**MODELS AFFECTED:** 407

**SUBJECT:** **ENGINE FAIRING, RH DOOR HINGE AND HOLD-OPEN MECHANISM – MODIFICATION OF.**

**HELICOPTERS AFFECTED:** 407 helicopters, S/N 53000 through 53330 and 53332 through 53345.

**Figure 1. Modification of Bracket**

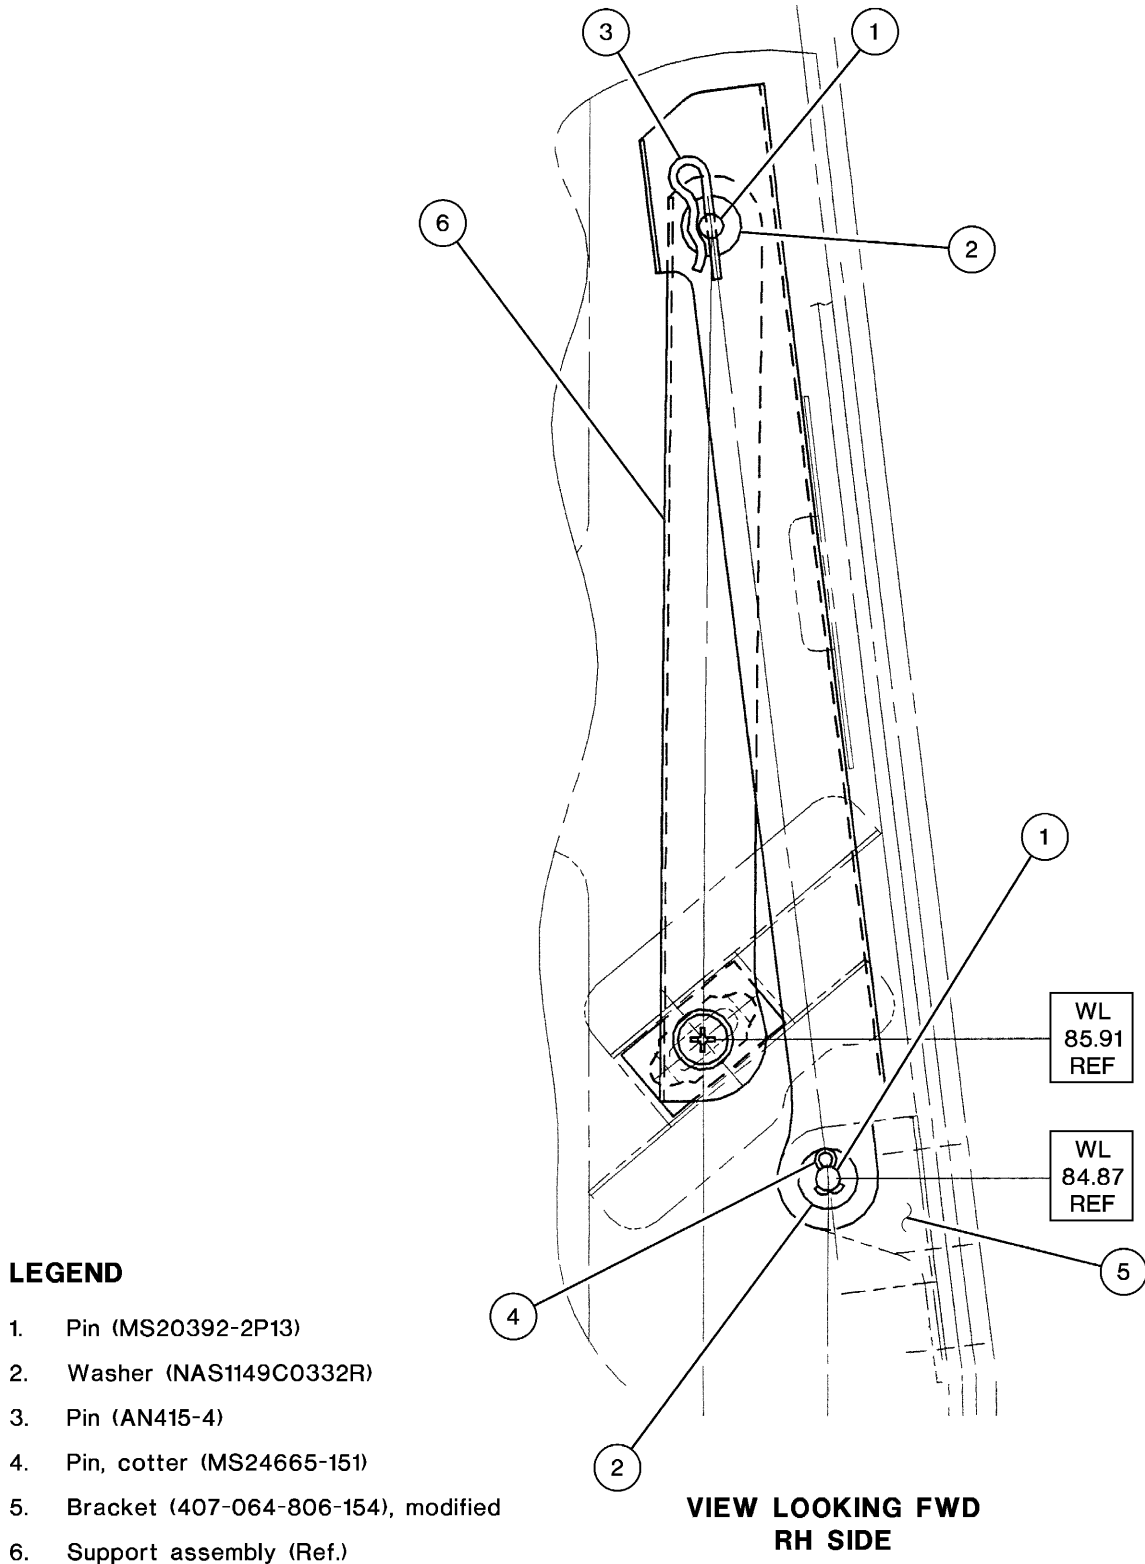
Bell Helicopter has found that the engine access door hinge and hold-open mechanism can possibly touch and cause damage to the fuel line on the airframe fuel filter.

This bulletin gives the instructions to re-route the fuel line and change the bracket for the hold-open mechanism on the door.

1. Remove the engine cowling (refer to BHT-407-MM-5, Chapter 53).
2. Use the supplied pattern (Figure 1) to transfer the new shape to the installed bracket.
3. Use aviation sheet-metal cutters, and cut the bracket as shown in Figure 1. Polish all sharp edges with a file or rotary grinder.
4. Install the engine cowling, that was removed in Step 1, on the helicopter (refer to BHT-407-MM-5, Chapter 53).
5. Change the location of the hinge pins for the hold-open mechanism on the right side only as shown on Figure 2.
6. Make sure that the fuel line (2, Figure 3) on the fuel filter assembly (1) is in the position shown (45° typical). If the line is not in the correct position, adjust the line.
7. Make an entry in the helicopter historical records to show that this Alert Service Bulletin has been completed.
8. Make an entry in the record of Alert Service Bulletin in the Maintenance Manual.

**PATTERN, SCALE: 1 = 1**  
**VIEW LOOKING AFT**  
**RH SIDE**  
**(ROTATED CCW)**
